ADDENDUM # 1

**BID TITLE: HURRICANE EMERGENCY REPAIRS
SCARBOROUGH STATE BEACH**

NOTICE OF ADDENDUM NO. 1

State of Rhode Island
DEM Planning and Development
Bid No. 7461239
Hurricane Emergency
Repair - Scarborough State Beach
Narragansett, Rhode Island

SIDEWALK GRINDING DETAIL

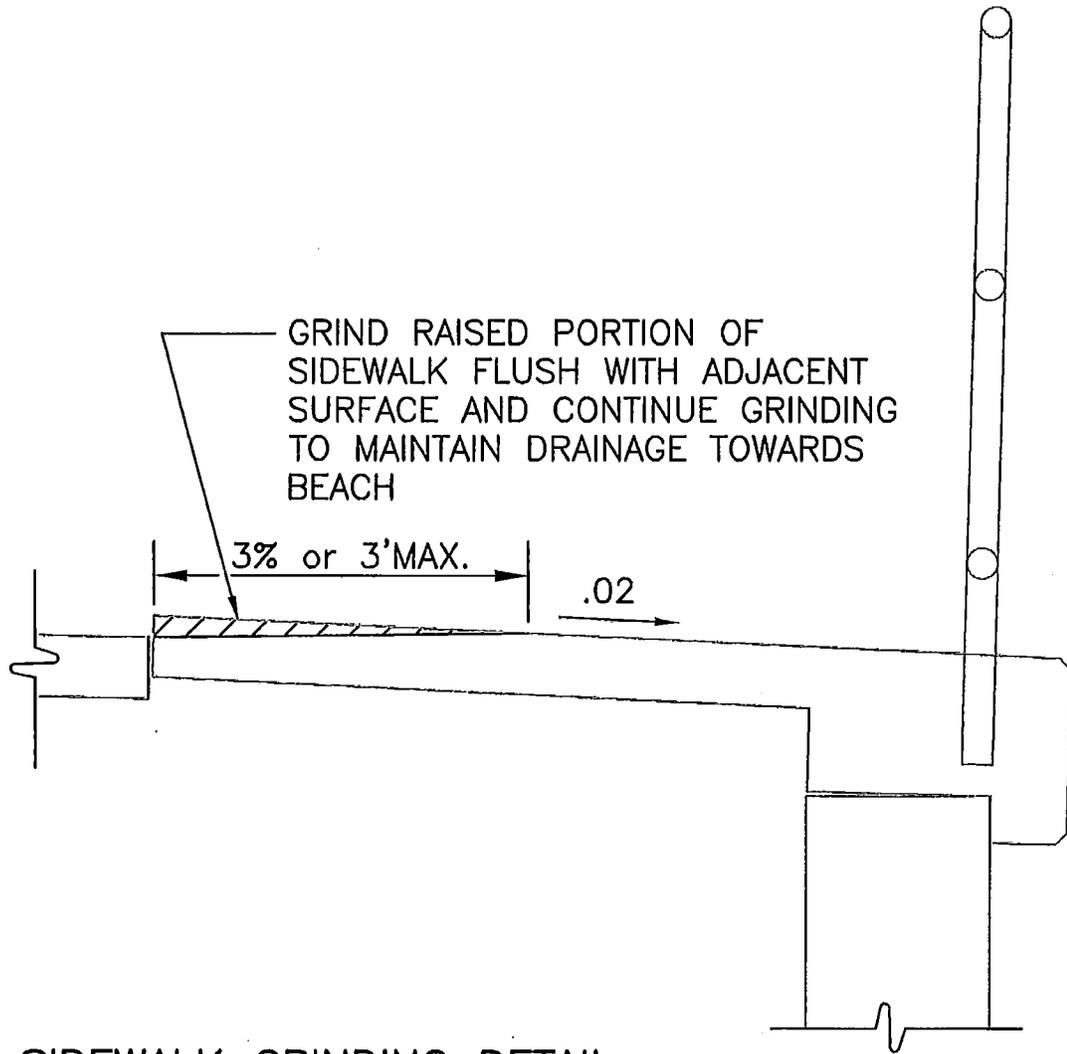
- 3. Reference BID ITEM - HRS-01 Scarborough Beach Page 20, Sketch No. 3.** Delete Sketch No. 3 and replace with the attached revised Sketch No. 3.
- 4. Reference BID ITEM - HRS-01 Scarborough Beach, Work Summary, Page 5 and 6, Work Area 16, & Page 10, Photographs 28 through 30.** The work shall include filling all voids below and adjacent to the sidewalk to be removed and replaced. Voids are anticipated to extent in all directions under the existing sidewalk repair. The Contractor shall include provisions for providing 80 cubic yards of flowable fill to fill these voids.

- 9) Is the work for Task H (Grinding Concrete Walkways) only on sidewalk along the Railing, as depicted in Sketch 3?

- 10) Is it the intention of this proposal for the work in Task H for the Railing to stay in place and conclude the grinding before it, as depicted on Sketch 3?

Response: The detail has been revised. The railings will not be impacted by grinding operations.
